RE: **Lot 19 Block 9 Unit 18 Volcano Cliffs SAD 228**
6508 Canavio Rd. NW
Grading and Drainage Plan
Engineers Stamp Date 3/30/2021 (D10D003I19)
Pad Certification Date 8/23/2021

DRAINAGE AND TRANSPORTATION INFORMATION SHEET (REV 6/2018)

| | GRADING AND DRAINAGE PLAN | DATE: 3-18-21 |

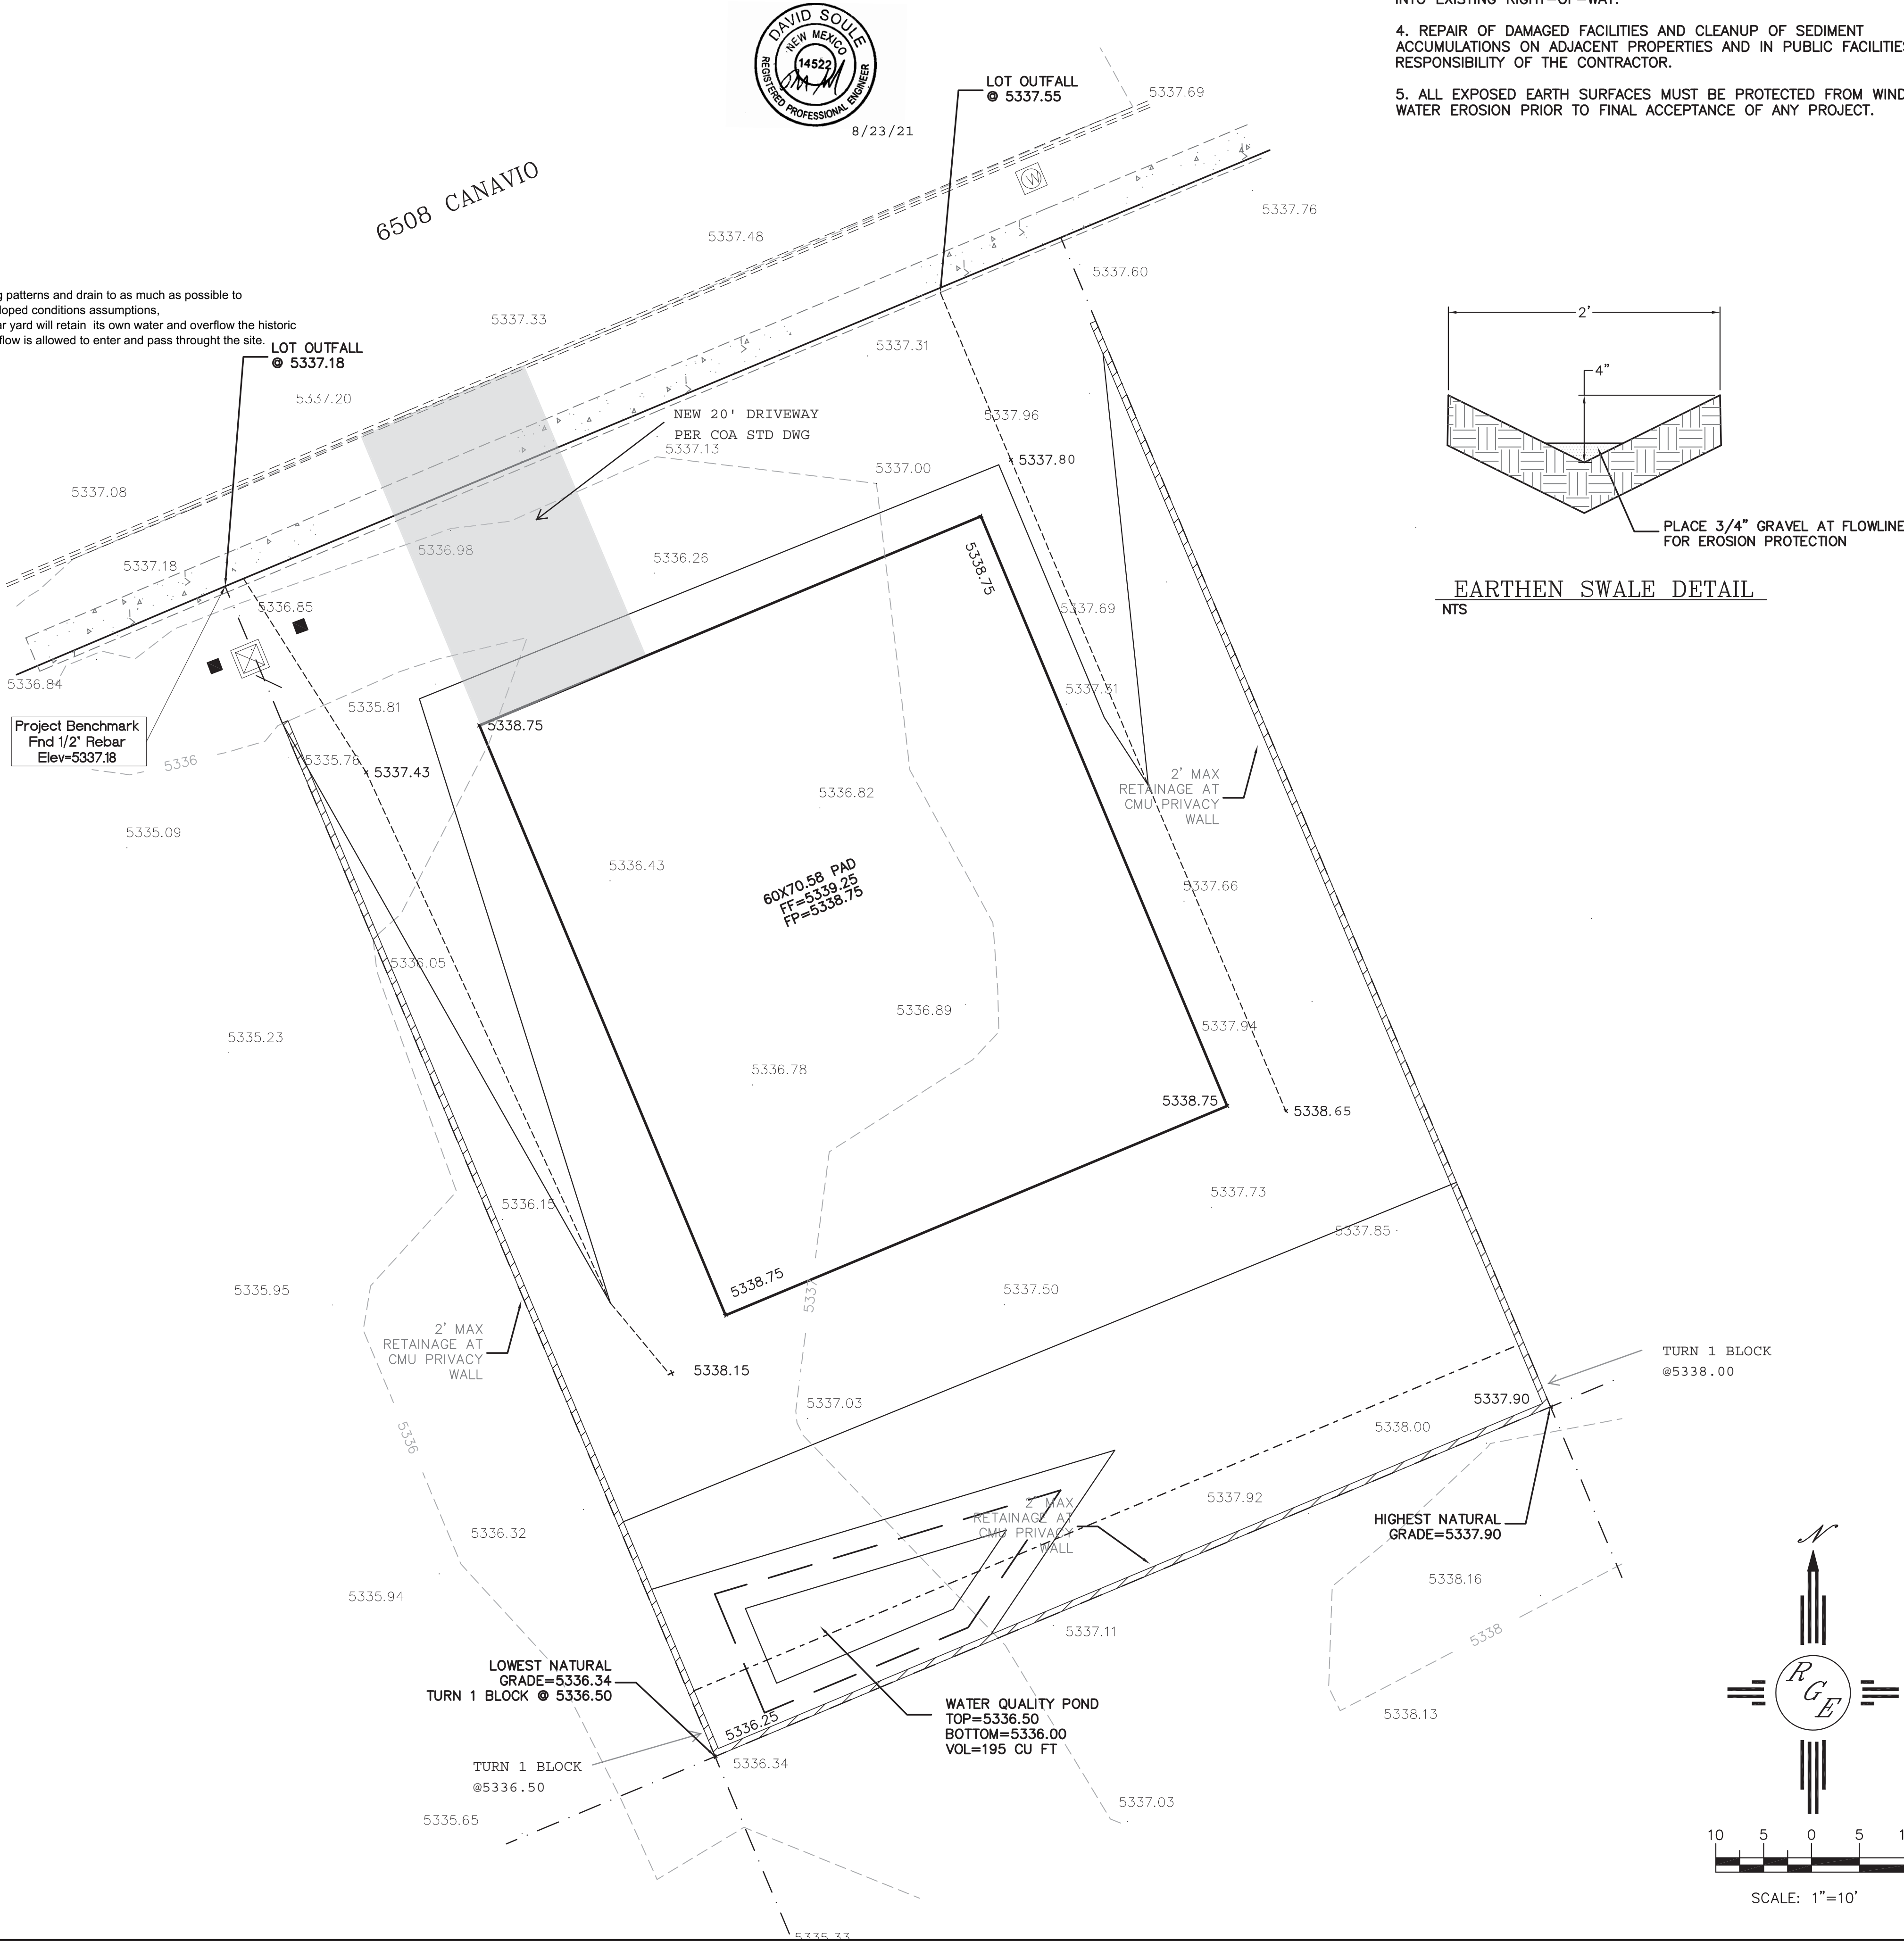
Based upon the information provided in your submittal received 8/31/2021, this plan is approved for Building Permit.

Reiterate to the Owner/Contractor that a separate permit for a garden/retaining wall must be obtained, with the approved G&D plan and Pad Certification. Also, let the owner/contractor know that if a pool is to be added in the future the G&D plan will need to be modified showing the location of the pool and the land treatment differences.

Prior to Certificate of Occupancy release, Engineer Certification per the DPM checklist of this plan will be required.
